Safety Alert

Re: Sweep failure incident in Puerto Rico.

Safety Bulletin

Purpose: Sweep Arm Cracking

INSPECTION AREA

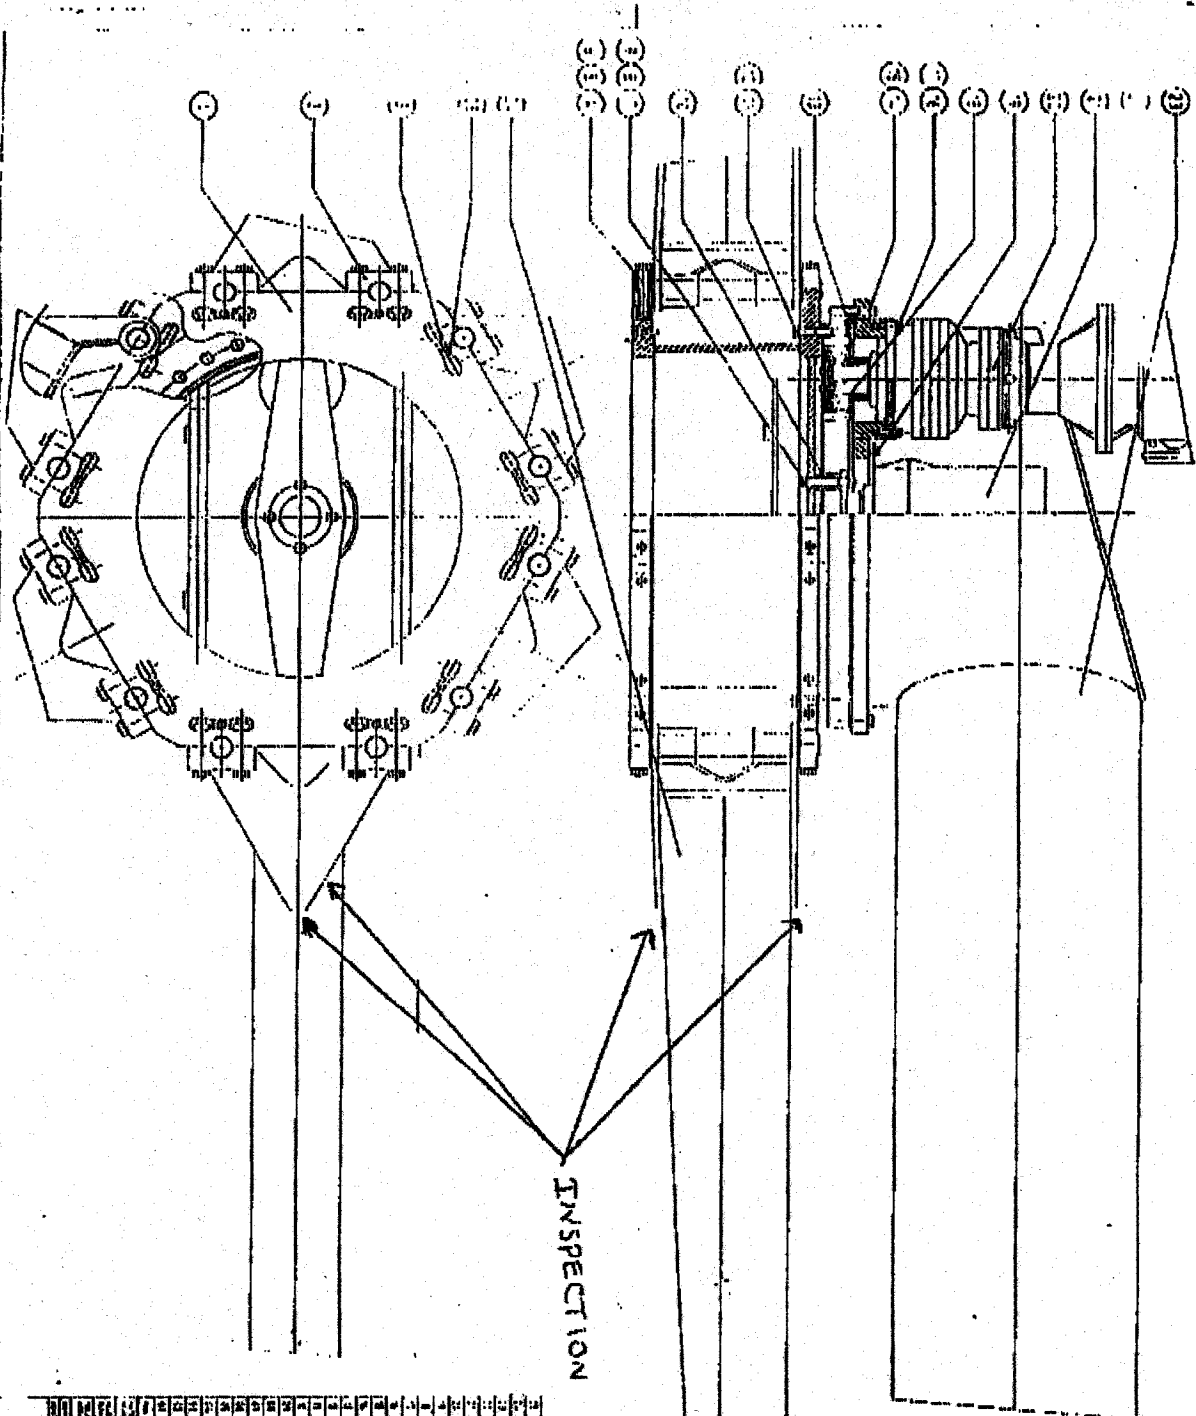
It has come to the attention of Tivoli Mfg. Ltd. from the original designers of the Spin Out, KMG Europe BV, that there has been cases where cracks have been detected on the sweep arms (see attached drawings) of Spin Out rides operating in Europe.

Tivoli Mfg. Ltd requires that all operators inspect the areas indicated on the attached drawings. If cracking is detected please report to AmTech / Amusement tech. intl. Inc. at 817-641-5045 for repair procedures and gusset kits.

If no cracks are detected as described in the attached drawing, a monthly inspection of this area of the sweeps should added to your existing inspection procedures.

As of the date of this bulletin gusset plates are not required unless cracking is detected. Rides manufactured to operate in Europe are run at different speeds than those operated in the USA, making it possible that this problem may only be applicable to rides operating in Europe. Please report to AmTech after inspection whether cracks are detected or not so proper action can be taken.

If required, gusset plates will be made available free of charge and can be ordered through Amtech / Amusement Technologies Int'l. Inc.
